RESPONSIVENESS SUMMARY TO THE PEER REVIEW OF MODEL VALIDATION: MODELING STUDY OF PCB CONTAMINATION IN THE HOUSATONIC RIVER

DCN: GE-111006-ADII

November 2006

**Environmental Remediation Contract
GE/Housatonic River Project
Pittsfield, Massachusetts**

Figure 2

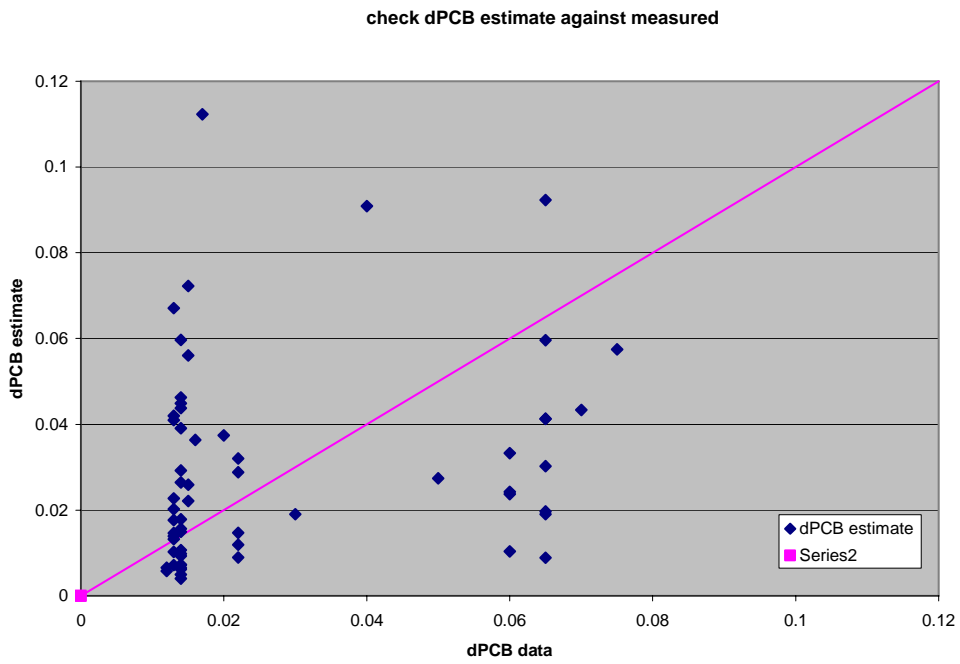
- 6 condition. This is shown below in Figure 2. If the partitioning model is being used to
- 7 describe the boundary condition, shouldn’t it fit the data?

Figure 3

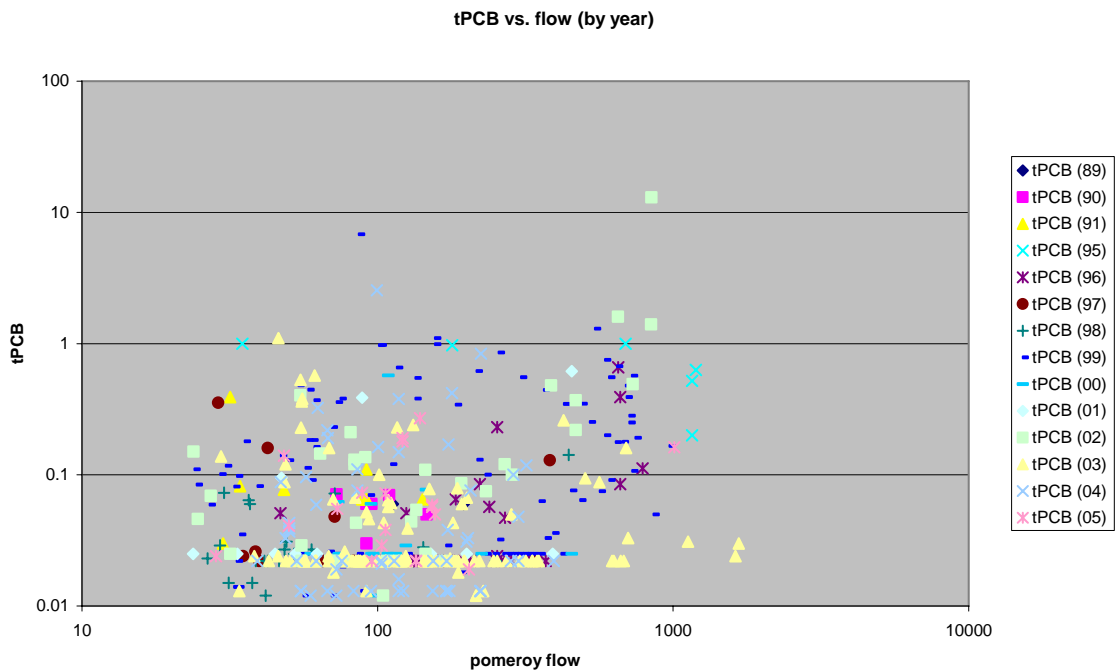
- 1 7. It is also curious to me that there has been no shift or evolution in PCB boundary
 2 concentrations over the past 16 years, and that seasonality is not evident in the data. If
 3 PCB boundary condition data for all years are plotted together, we see the familiar
 4 shotgun target (Figure 3). There appears to be some underlying behavior, however,
 5 within individual years of data. Figure 4 shows total PCB data for years (especially 2002)
 6 in which a positive relationship with flow is evident. Figure 5 shows total PCB data for
 7 years (2003 in particular) in which the flow relationship is generally negative. The
 8 highest total PCB concentrations in Figure 5 come from the warm (and presumably
 9 higher organic carbon²) months of July-September, while the lowest PCB concentrations
 10 at very high flow were sampled in October and November. While I am confident EPA
 11 has looked at this data in great detail, I think the patterns in the data hinted at here

11 **Figure 6**

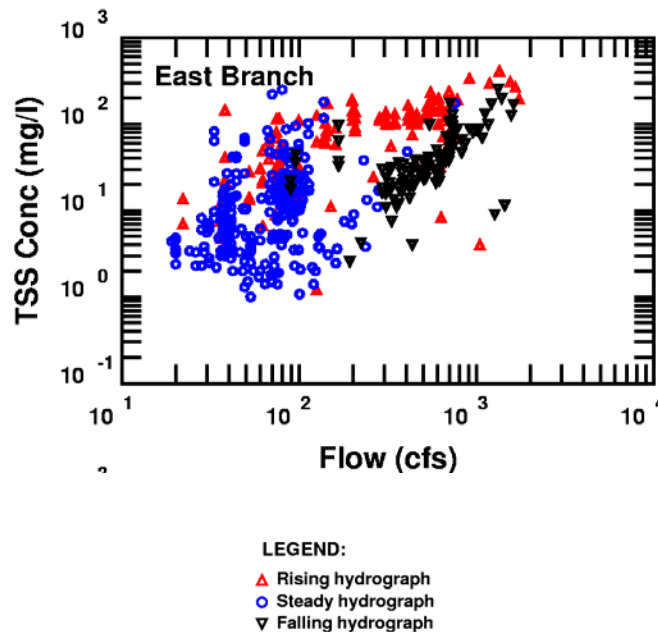
1 9. I also went back to look at the TSS boundary condition, which has not been changed
 2 from the Phase 1 calibration. Figure 6 is a reproduction of the plot displaying the East
 3 Branch TSS data as a function of flow (from: Volume 3—Appendix B Hydrodynamic
 4 and Sediment/PCB Fate and Transport Model Calibration, Attachment B.3 TSS and PCB
 5 Flux Analysis). The TSS data were partitioned according to 3 phases of the hydrograph –
 6 rising, steady and falling. TSS data are well-behaved during rising and falling
 7 hydrographs, but not at steady (and predominantly low) flow. This makes me wonder
 8 again about seasonal factors, intermittent upstream disturbances, or possibly sampling
 9 artifacts. It is hard to imagine TSS concentrations varying between 1 and 100 mg/L at
 10 base flow.

Figure 6.2-5 Comparison of Measured and Simulated Flow and Elevation at Five Stations During the October 2003 Storm Event

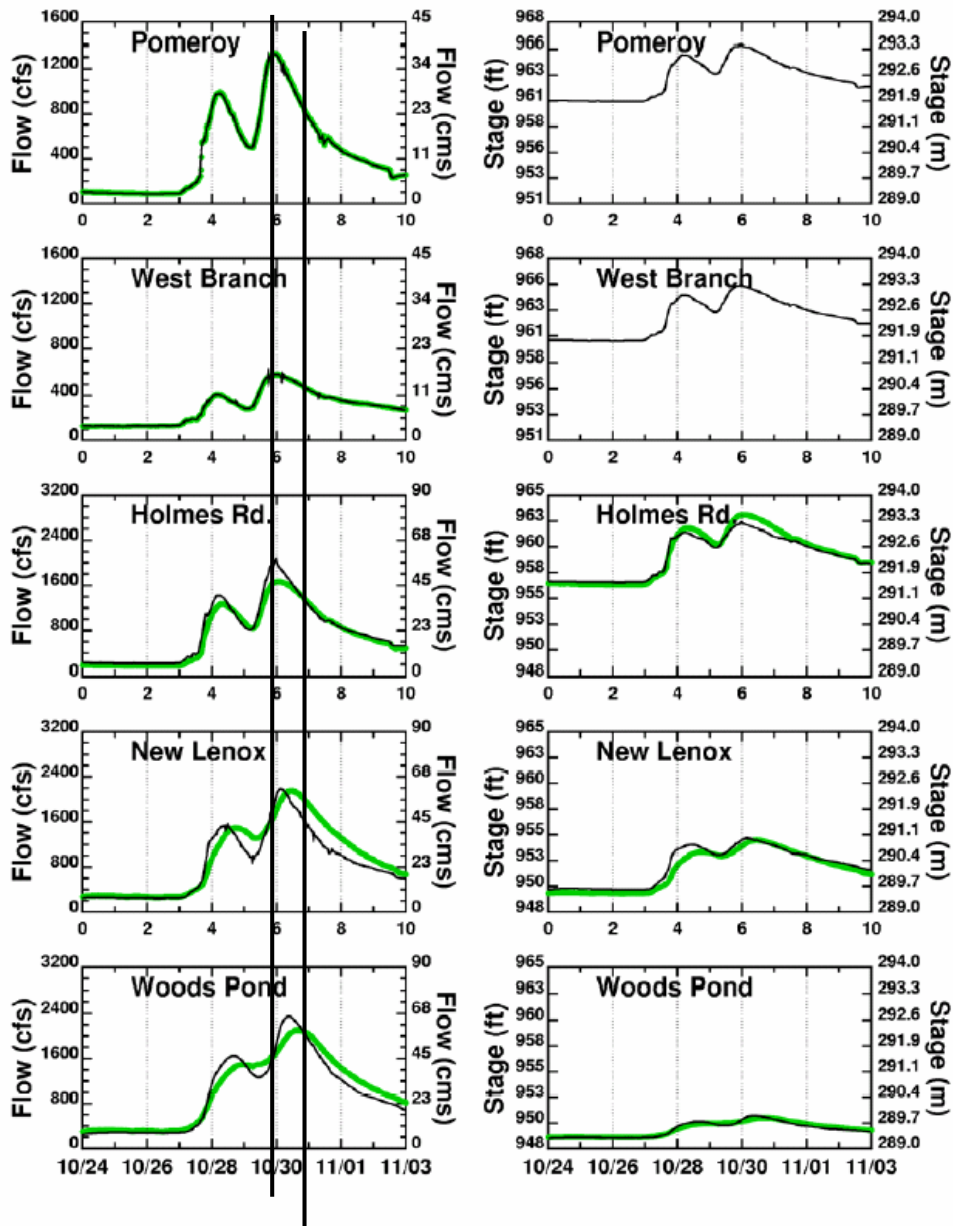
1 similar to that observed. These references to “event timing” leave the question of the adequacy of
2 the model simulation of timing with respect to flow velocities unanswered. Examination of
3 several of the figures (see Fig. 6.2-5 (attached) e.g.) shows substantial differences between
4 measured and modeled actual flow and stage timing at several stations along the PSA. In this
5 figure, it would appear that the modeled speeds produced by the associated pressure gradients
6 should be less than the measured and that the turbulence induced by adverse pressure gradients
7 would also be reduced. Actual estimation is, of course, complicated by the morphology of the
8 region with tributary inflows and/or backwater flows and storage complicating the simple stage
9 discharge relationship. This factor may be the reason for example that the simulated flows at
10 Holmes Road are higher than the measured despite a higher measured stage relative to that

25 Reviewer (MVR Figure 6.2-5), approximately one-third of the flow passing Woods
26 Pond Footbridge is based on HSPF’s simulated tributary inflows and direct runoff
27 between the confluence and Woods Pond Footbridge. The discussion of this
28 simulation recognizes the sensitivity to HSPF results, particularly because the
29 double peak in the hydrograph indicates that two closely spaced events were
30 simulated.

Figure 2

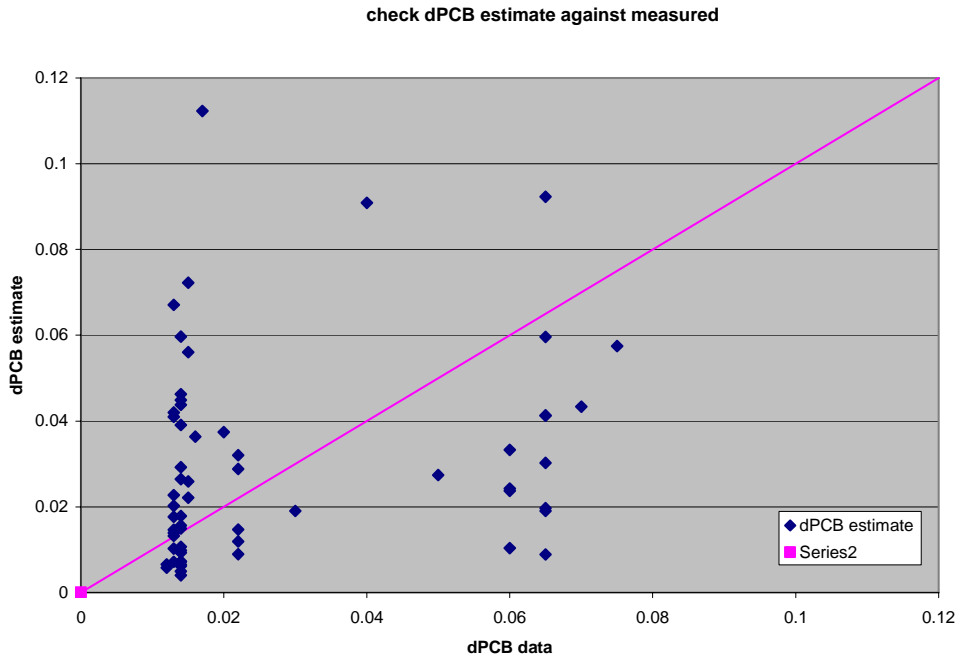
- 30 2. I cannot find the PCB concentration data collected at flow rates smaller than 24 cfs³. Therefore, I
31 have no way to confirm the results shown in Figure 4.1-2 for the two lowest-flow “bins”. At least
32 for the lowest “bin”, the regression line appears to be a poor fit. A noted above, it exceeds all of
33 the measured data.

Figure 3

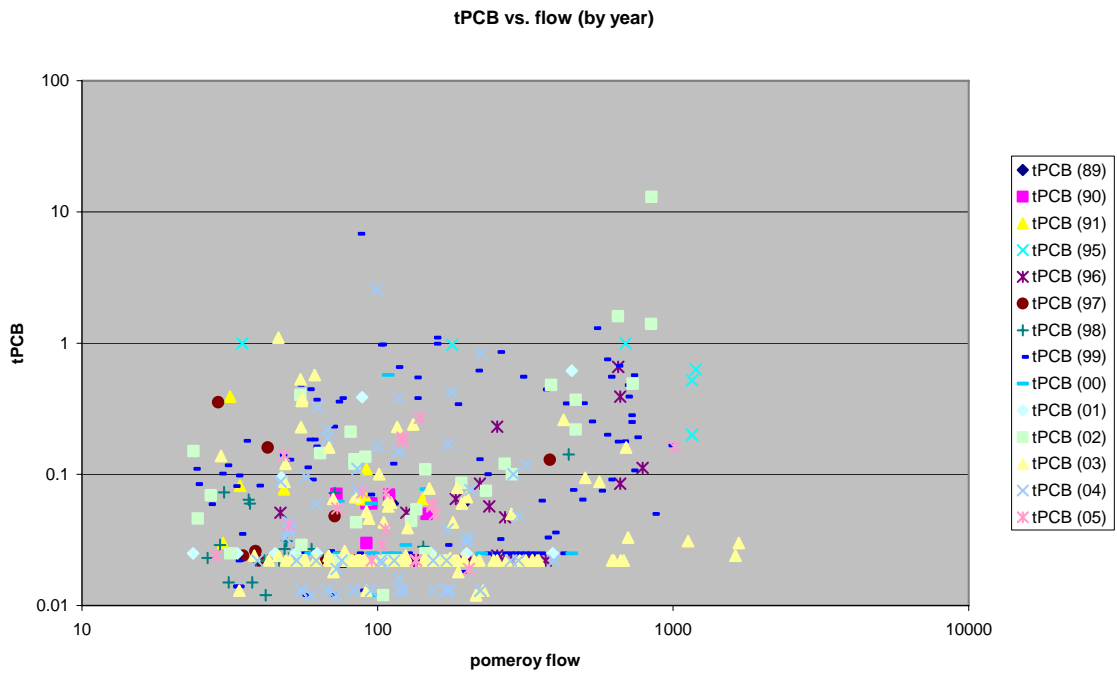
- 13 7. It is also curious to me that there has been no shift or evolution in PCB boundary concentrations
14 over the past 16 years, and that seasonality is not evident in the data. If PCB boundary condition
15 data for all years are plotted together, we see the familiar shotgun target (Figure 3). There appears
16 to be some underlying behavior, however, within individual years of data. Figure 4 shows total
17 PCB data for years (especially 2002) in which a positive relationship with flow is evident. Figure
18 5 shows total PCB data for years (2003 in particular) in which the flow relationship is generally
19 negative. The highest total PCB concentrations in Figure 5 come from the warm (and presumably
20 higher organic carbon⁴) months of July-September, while the lowest PCB concentrations at very
21 high flow were sampled in October and November. While I am confident EPA has looked at this
22 data in great detail, I think the patterns in the data hinted at here suggest some underlying behavior

11 **Figure 6**

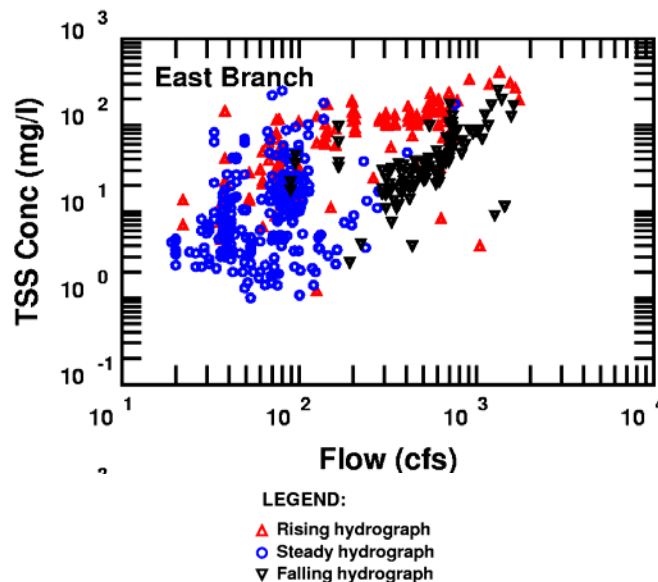
1 9. I also went back to look at the TSS boundary condition, which has not been changed from the
2 Phase 1 calibration. Figure 6 is a reproduction of the plot displaying the East Branch TSS data as a
3 function of flow (from: Volume 3—Appendix B Hydrodynamic and Sediment/PCB Fate and
4 Transport Model Calibration, Attachment B.3 TSS and PCB Flux Analysis). The TSS data were
5 partitioned according to 3 phases of the hydrograph – rising, steady and falling. TSS data are well-
6 behaved during rising and falling hydrographs, but not at steady (and predominantly low) flow.
7 This makes me wonder again about seasonal factors, intermittent upstream disturbances, or
8 possibly sampling artifacts. It is hard to imagine TSS concentrations varying between 1 and 100
9 mg/L at base flow. (6)
